Access Compliance Report

Public Rights-of-Way

(Curb Ramps)

Intersection ID: 29172	Main Street: BOXELDER_LN	Cross Street: WHITEBARK_CT	Location: E
ADA ID: 216DDD10297F	Ramp Type: PerpDiag	Initial Pass/Fail: Fail	Overall Compliance: No
		Severity Score: 8.75

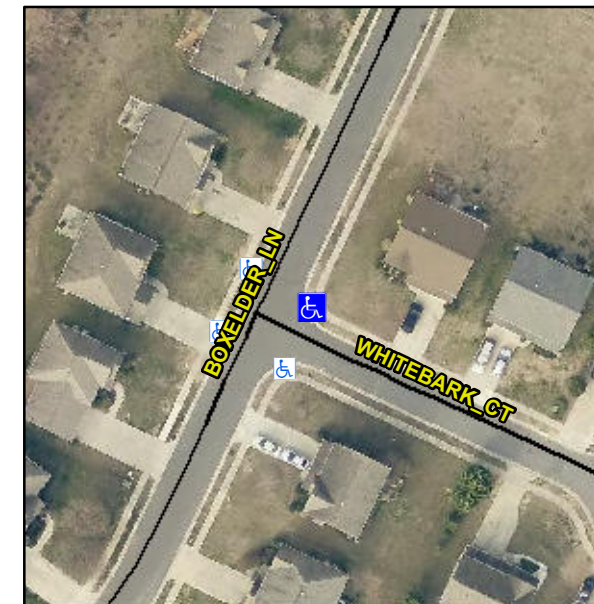
Not Found, R304.5.1

Compliance	Description	Data	Compliance	Description	Data
N/A	Ramp Length (in)	48.0	Yes	Ramp Slope (%)	5.5
No	Ramp Width (in)	40.0	Yes	Ramp XSlope (%)	1.5
N/A	Flare Type LT	N/A	N/A	Flare Type RT	N/A
N/A	Flare Slope LT (%)	N/A	N/A	Flare Slope RT (%)	N/A
N/A	Flare Traversable LT?	N/A	N/A	Flare Traversable RT?	N/A
N/A	Landing Length (in)	N/A	N/A	DWS Provided?	N/A
N/A	Landing Width (in)	N/A	N/A	DWS Contrast?	N/A
N/A	Landing Slope (%)	N/A	N/A	DWS Length (in)	N/A
N/A	Landing X Slope (%)	N/A	N/A	DWS Full Width?	N/A
N/A	Landing Curb? (Y/N)	N/A	N/A	DWS Offset (in)	N/A
N/A	Shared Landing?	N/A			
N/A	Gutter Ponding?	N/A	N/A	Gutter Slope (%)	N/A
N/A	Gutter Lip Ht (in)	N/A	N/A	Gutter X Slope (%)	N/A
N/A	Painted X Walk1?	No	N/A	Painted X Walk2?	No
	X Walk 1 Direction	To NW		X Walk 2 Direction	To SW
N/A	X Walk 1 Width (in)	N/A	N/A	X Walk 2 Width (in)	N/A
	X Walk 1 Slope (%)	7.1		X Walk 2 Slope (%)	8.1
	X Walk 1 X Slope (%)	5.9		X Walk 2 X Slope (%)	4.5

Remove & Replace Curb Ramp With Two New Directional Ramps or Equivalent.
